**Recall of Liko M220, Liko M230 from Liko AB.**

## Field Safety Notice

**FA 2021-010-002-LUL-001**

**Subject:** Missing bushing on Liko M220 and M230 causing wear and potential for falls.

Figure 1: Mechanism and parts included in the sling bar for M220/M230. Bushing marked in red.

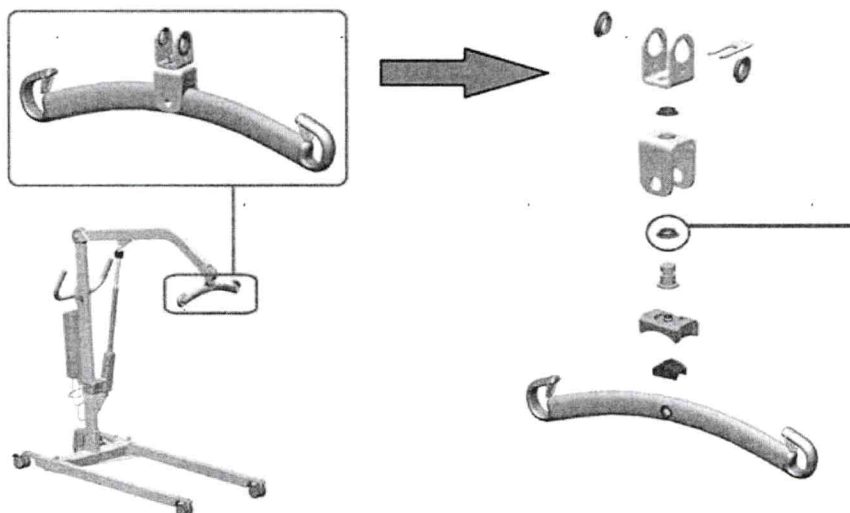
Hillrom has received customer complaints whereby a Slingbar had detached from the upper bracket of the sling bar attachment. Investigations indicated that a bushing was missing on the product. The missing bushing causes wear on the Slingbar attachment, which in turn can potentially cause the sling bar to detach from its attachment. If the slingbar detaches from the upper bracket, this has the potential for patient falls.

Hillrom investigation determined that the root cause of the slingbar detachment is caused by wearing at the slingbar attachment due to the missing of a plastic bushing (see red markings in Figure 1) as part of the assembly during manufacturing of the device. It was determined that assembly of this device has the potential to not contain this plastic bushing on devices manufactured between 2016-DEC-27 and 2021-SEP-01.

A missing plastic bushing on the device can cause wearing on the slingbar attachment. Over time, this wearing can cause the slingbar to detach from the lift, which may result in a patient fall. Hillrom can confirm there have been no death or serious injuries reported from this failure.

Upon receipt of the response form, identifying potentially impacted devices, Hillrom or an official Hillrom distributor/representative will be in contact to schedule inspection of your device to confirm presence of the bushing. Where it is confirmed that the device is missing the bushing, a replacement slingbar with the bushing will be installed.

Figure 2: Placement of the label and its designs. Left: New design. Right: Old design.

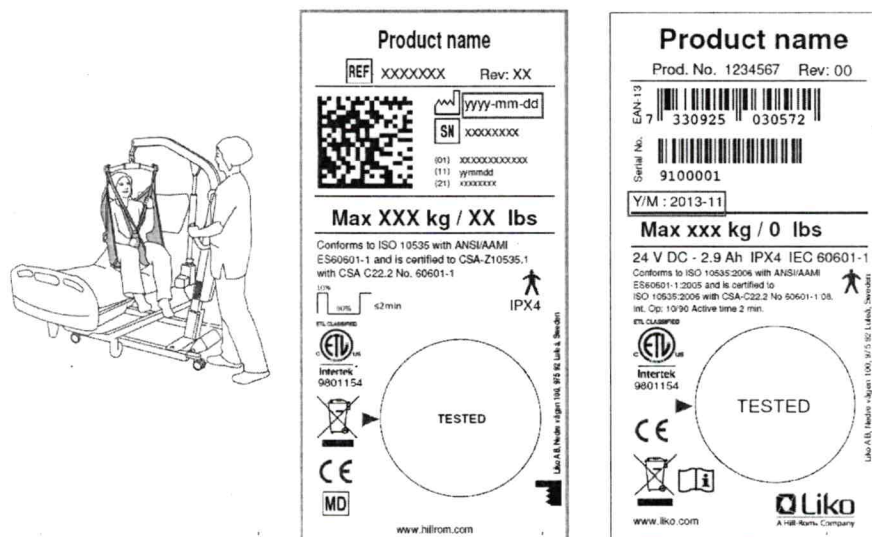
1. Review the product label on your Liko M220/M230 to determine if it is impacted by this field action by identifying the manufacturing date of the device (i.e. Manufacturing date between 2016-DEC-27 and 2021-SEP-01). See figure 2.
